PLANNING REPORT

Architectural Review Board

55 W. Bridge Street – MASTER SIGN PLAN

Agenda Item	1
Case Number	17-030ARB/MSP
Proposal	A Master Sign Plan for Johnson's Real Ice Cream including one blade sign and one awning sign.
Request	Review and recommendation of approval to the Architectural Review Board for a Master Sign Plan under the provisions of Zoning Code Section 153.066 and 153.170 and the *Historic Dublin Design Guidelines*.
Site Location	Located on the south side of West Bridge Street. Approximately 100 feet east of the intersection with Franklin Road.
Applicant	Matt Wilcoxon, Johnson's Real Ice Cream
Case Manager	Logan Stang, Planner I | 614.410.4652 | lstang@dublin.oh.us Cameron Roberts, Planning Assistant | 614.410.4663 | croberts@dublin.oh.us
Planning Recommendation	***Approval*** Approval is recommended of the Master Sign Plan with two conditions: 1) The secondary images (ice cream cone logos) on the sides of the awning sign be removed, prior to filing for sign permits. 2) The secondary image size for the projecting sign should be revised to meet Code.

Proposed Awning Sign

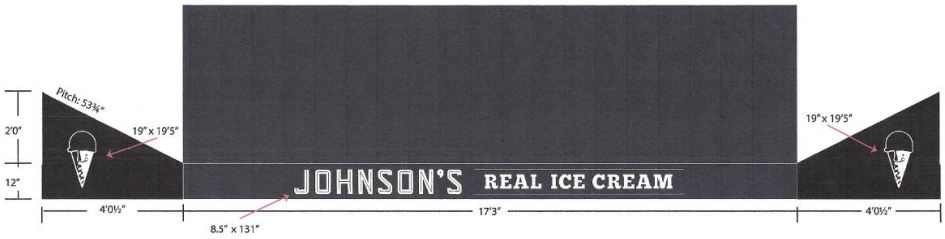
Details	**Master Sign Plan – Awning Sign**	
	Criteria	**Proposal**
Number/Type	Maximum two building mounted sign permitted for each ground floor tenant with a storefront. An additional building-mounted sign is permitted for tenants with a dedicated public entrance located on the side of rear façade of the building with access to parking in the same block. (3 signs permitted).	***Met.*** One (of two) building mounted signs.
Size	20% of the cumulative surface of all awnings, not to exceed 8 sq. ft.	***Met.*** 7.73 square feet.
Location	Any portion of the awning; affixed flat to surface; shall not extend vertically horizontally beyond limit of awning.	***Met.*** Sign affixed to single flat surface within awning limits.
Height	Maximum 15 feet; shall be at least 8 feet above the sidewalk.	***Met.*** Awning to be located at a height of 8 feet 6 inches from grade.
Colors	Maximum 3 colors.	***Met.*** 2 colors (black background with white copy)

Secondary Image	Shall not exceed 20% of the sign area, not including corporate trademarks or logos.	***Met with Condition.*** Removal of proposed secondary images, ice cream cone logos, on sides of awning to meet secondary image size requirements and remain

Details	**Master Sign Plan – Awning Sign**
Criteria	**Proposal**
	consistent with previously approved awning signs in the Historic District.
